PROJECT NUMBER **HEARING DATE**
TR066952 TBD

Vesting Tentative Tract Map No. 066952
Conditional Use Permit No. 200700038
Environmental Assessment No. 200700035

SUBDIVISION COMMITTEE REPORT

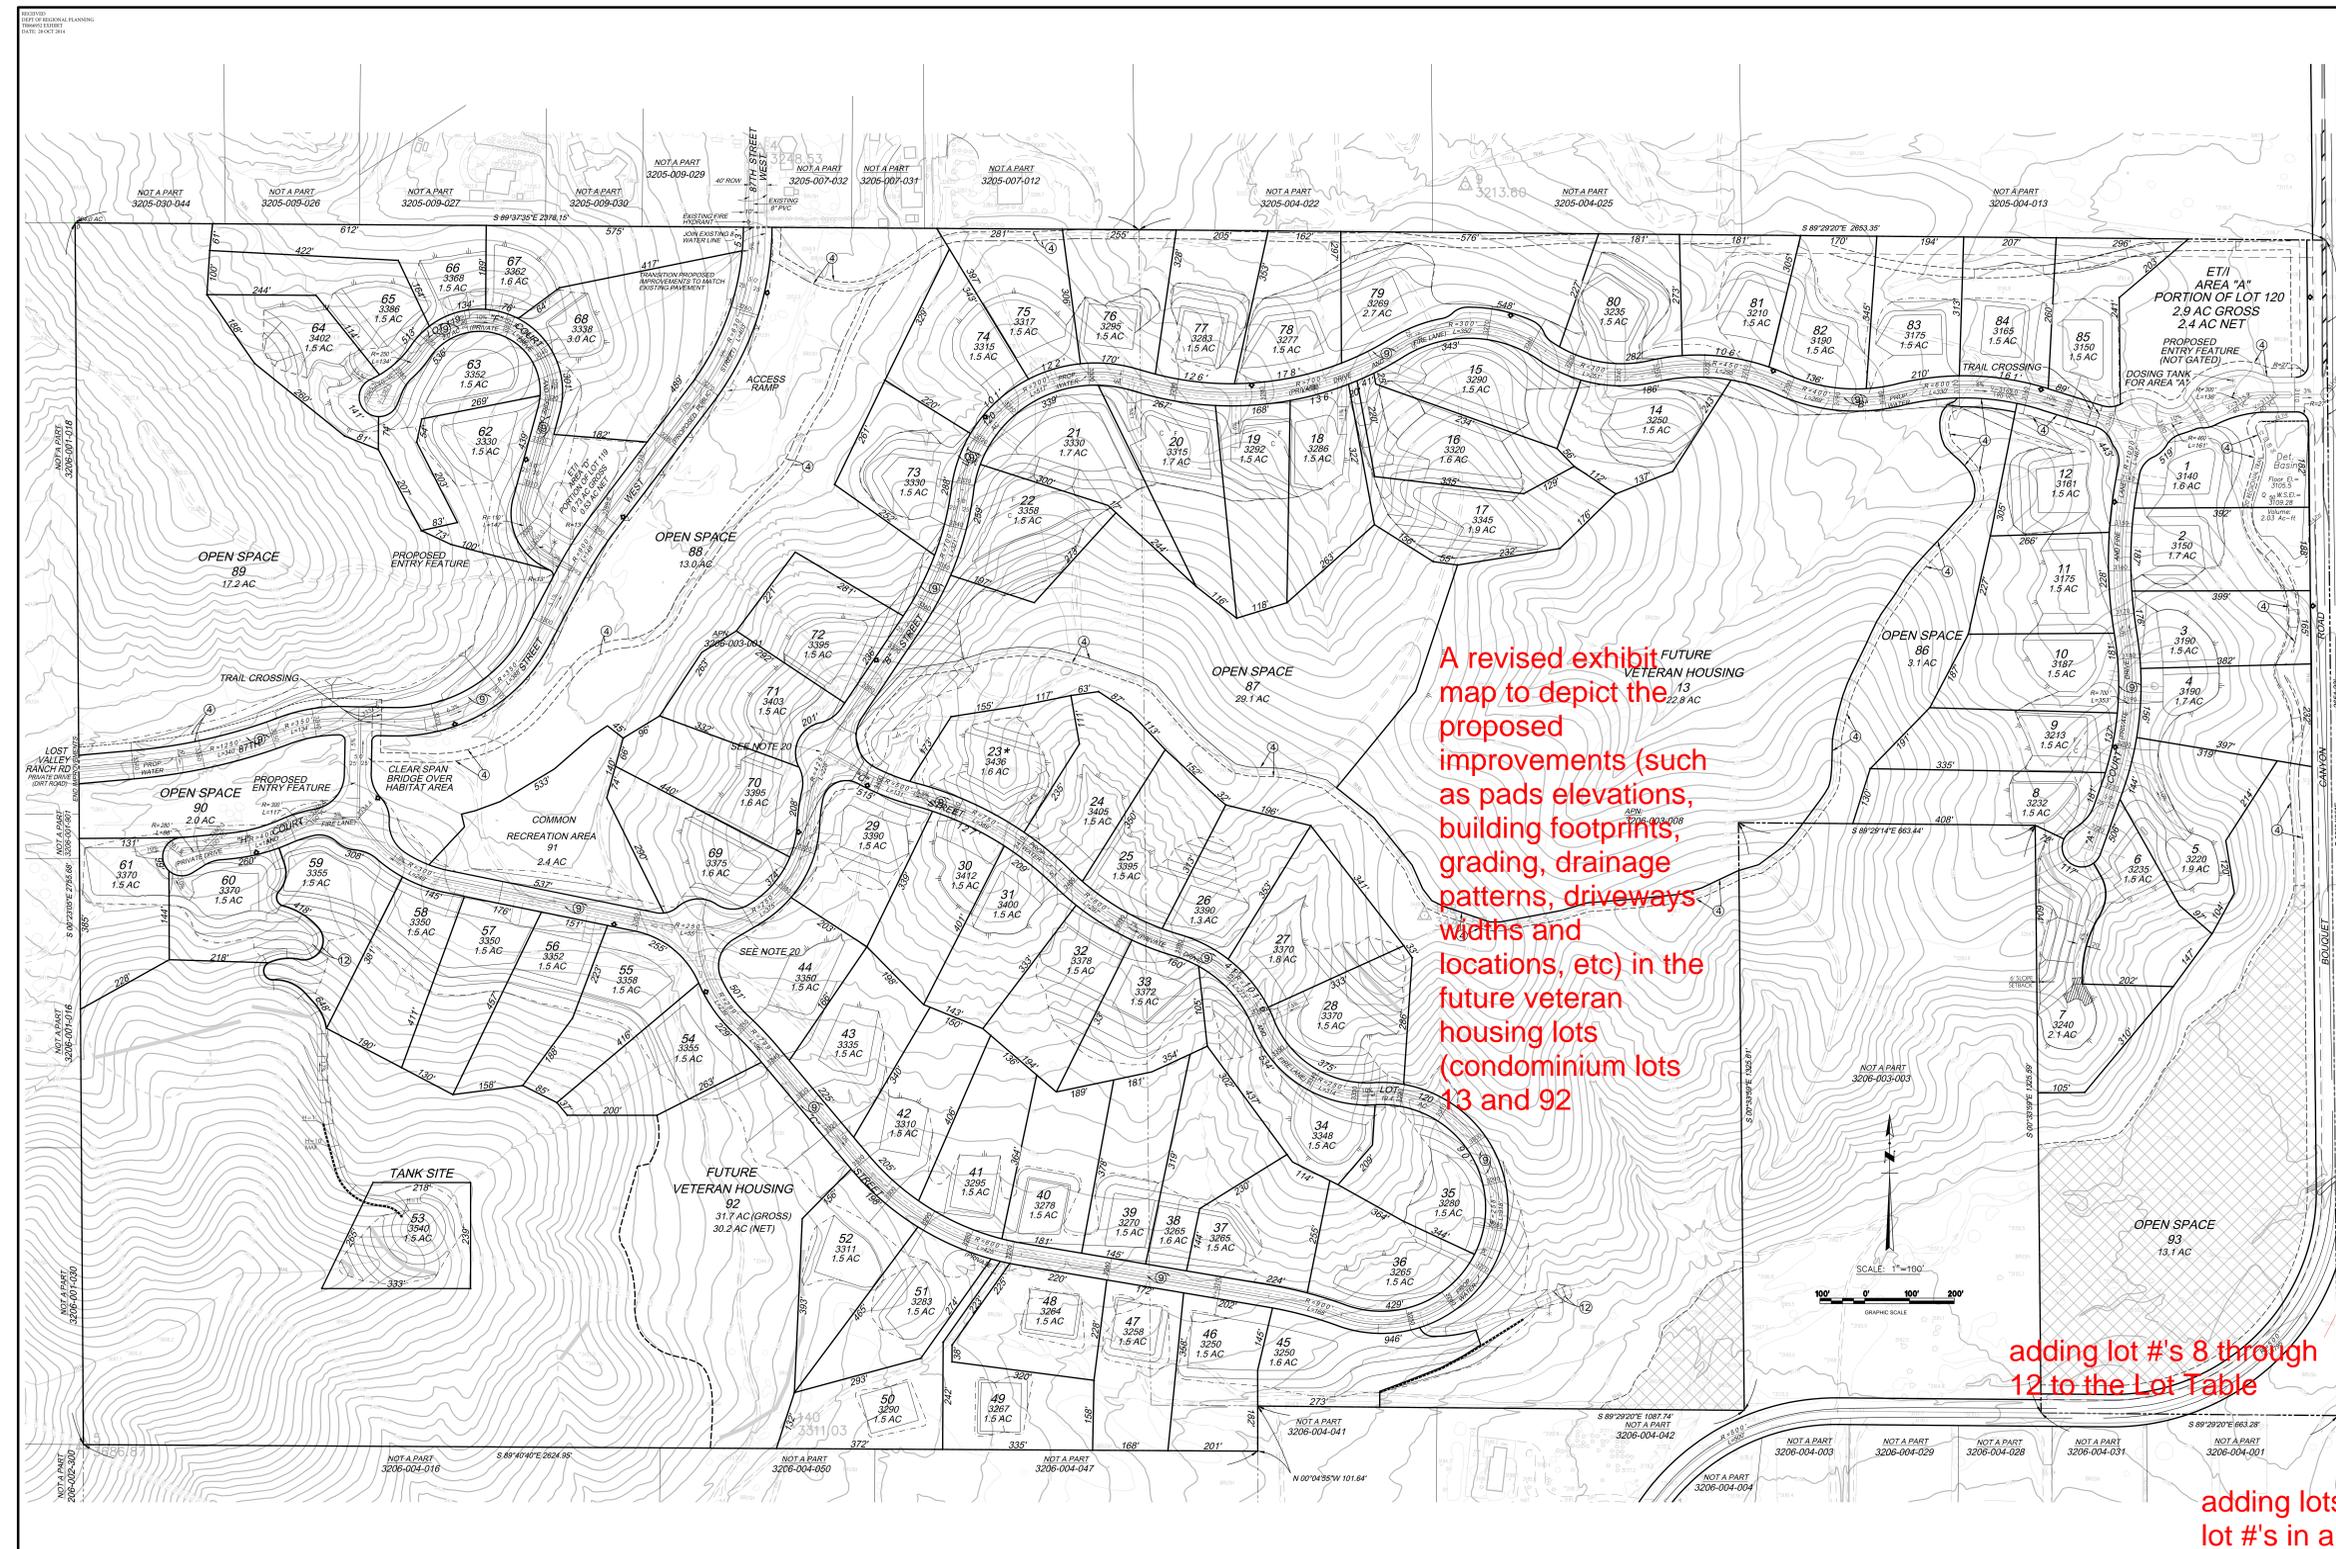
A revised exhibit map to depict the proposed improvements (such as pads elevations, building footprints, grading, drainage patterns, driveways widths and locations, etc) in the future veteran housing lots (condominium lots 13 and 92

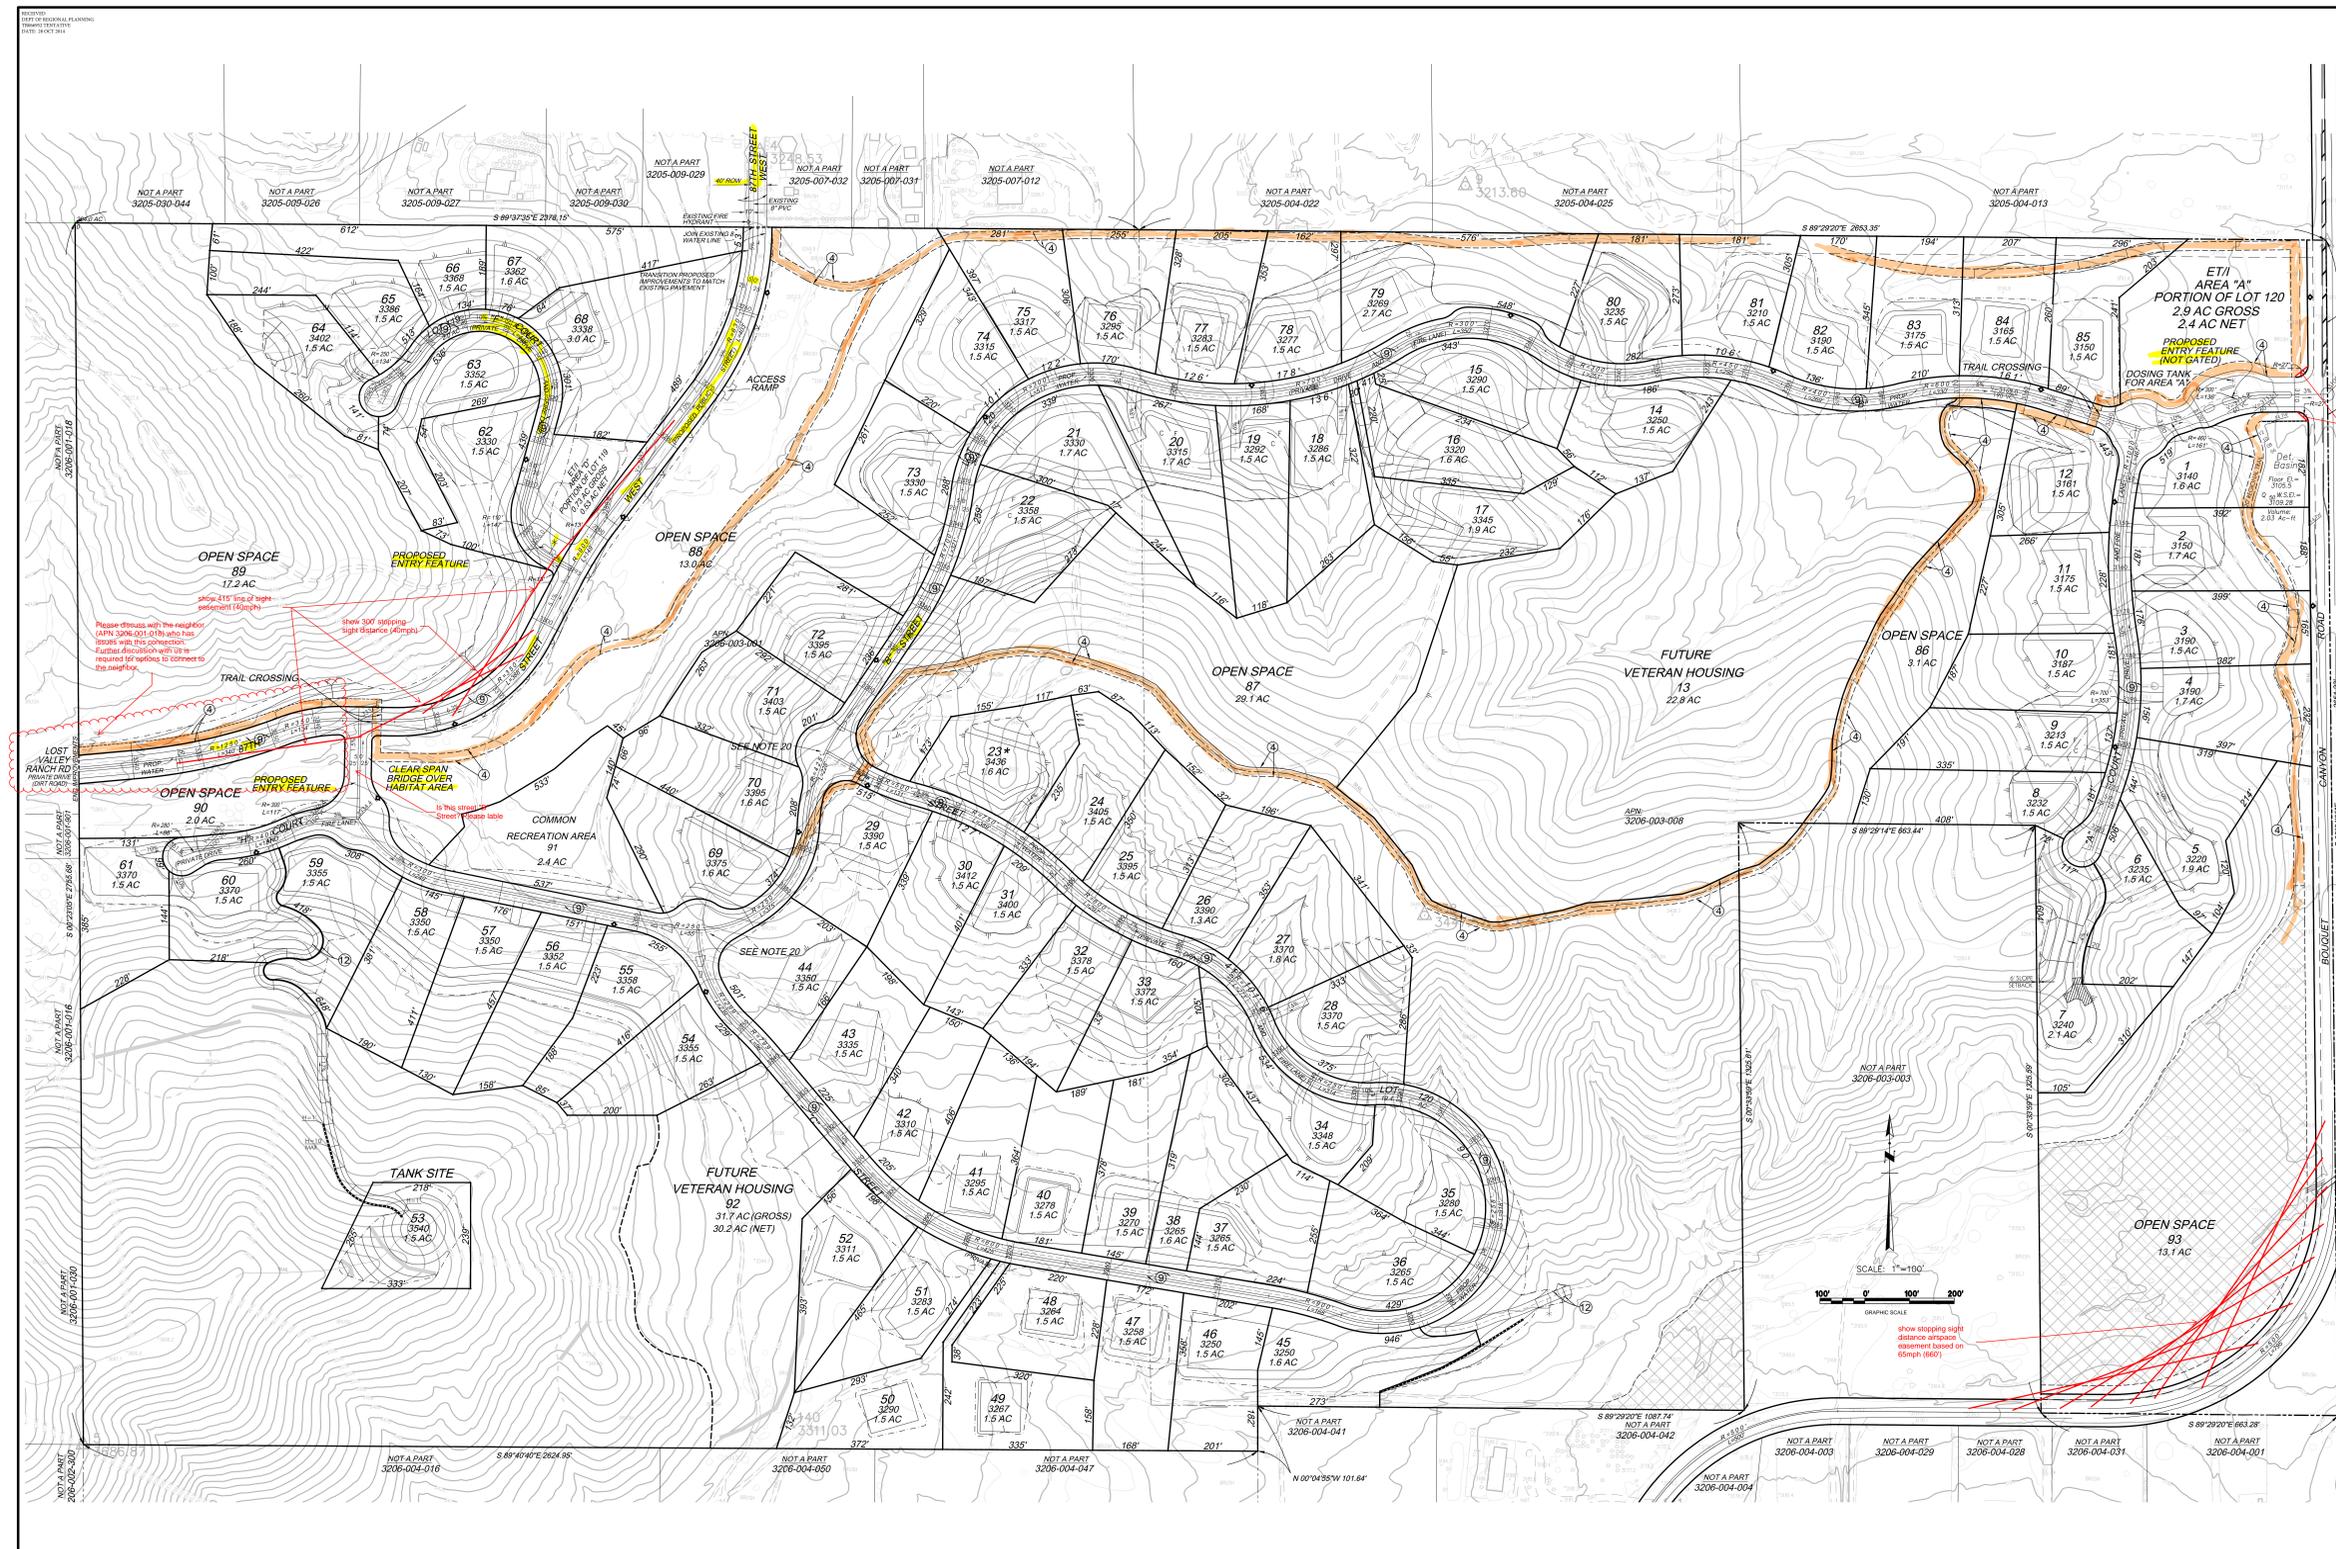
- (1) A revised tentative map and exhibit map is required. See additional road comments as shown in the attached files (2014-11-12 TTR 066952 dated 2014-10-29 RD checkprint.pdf and 2014-11-12 TTR 066952 Exhibit Map dated 2014-10-29 RD checkprint.pdf) which can be found at the following ftp link:
<ftp://dpwftp.co.la.ca.us/pub/LDD/Road/TTR%20066952rev5/>

SUBJECT: **NOTICE OF TRACT MAP TRAIL REVIEW FOR
TENTATIVE TRACT MAP (TTM) # 66952
(MAP STAMPED BY REGIONAL PLANNING ON OCTOBER 28, 2014)**

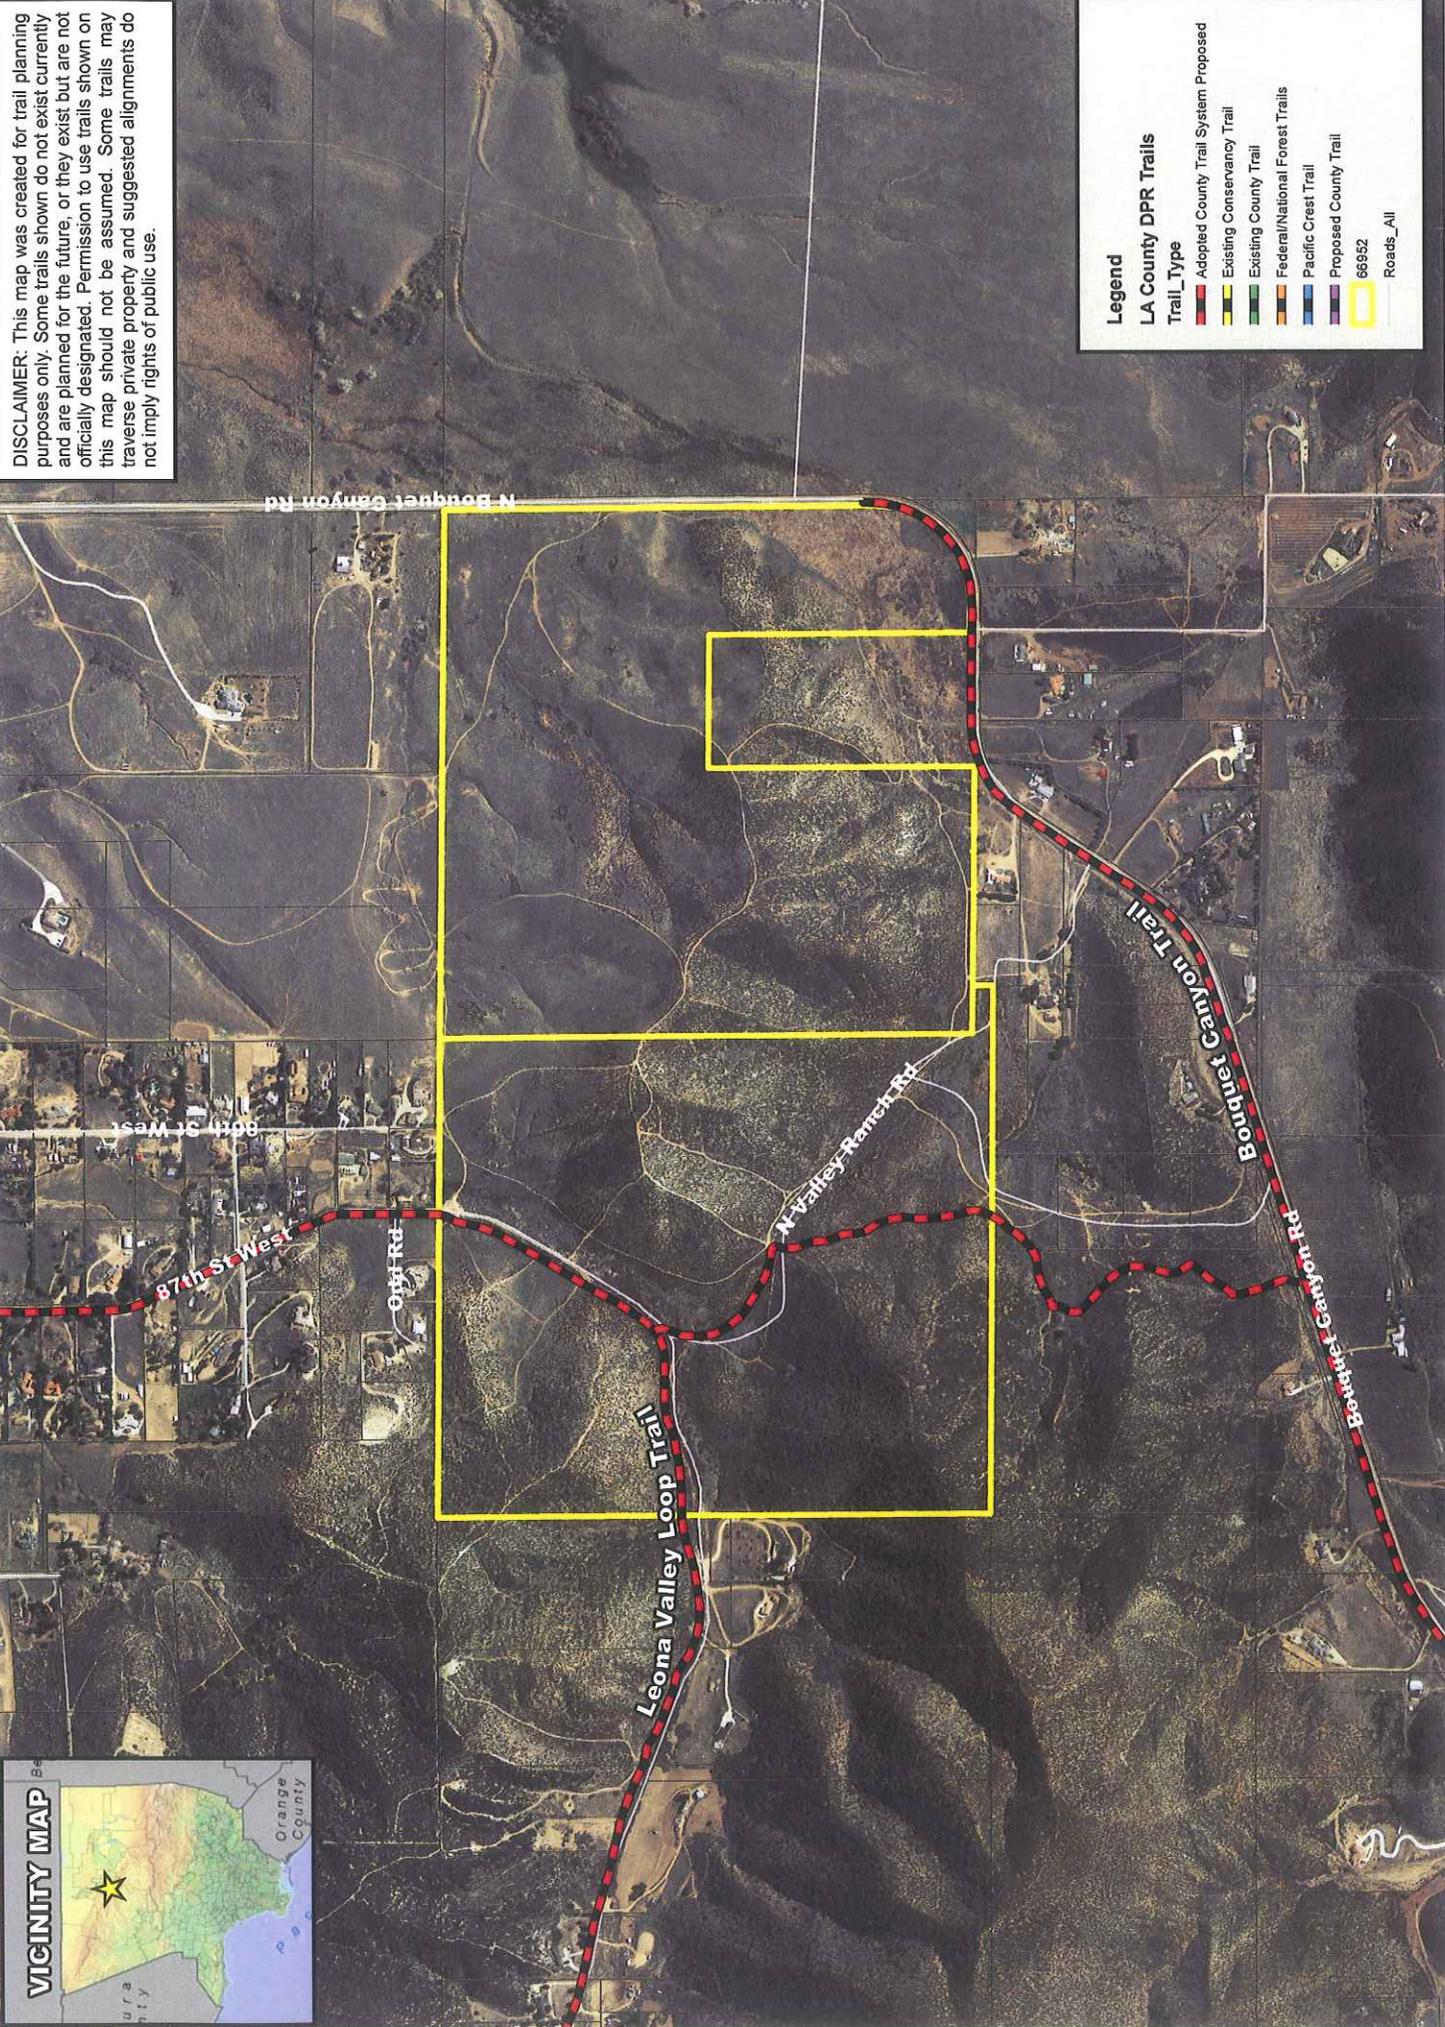
The Department of Parks and Recreation, Trail Planning Section (Department) has completed the trail review for Vesting Tentative Tract Map No. 066952. The Department requires the dedication of a minimum twelve foot (12') wide trail easement for multi-use (hiking, mountain biking, and equestrian) purposes, to be designated as the "Leona Valley Loop Trail" and "Bouquet Canyon Trail", the dedication of a blanket easement for multi-use trail purposes and the trail improvements and/or construction consistent per the County of Los Angeles Trail Manual. Please see the attached trail map.

Further research and clarification is needed to ensure the proposed trails will provide improved trail access and connectivity. Please contact Park Planner, Robert Ettleman, at (213) 351-5134 or rettleman@parks.lacounty.gov to discuss map revisions as they pertain to trail requirements.
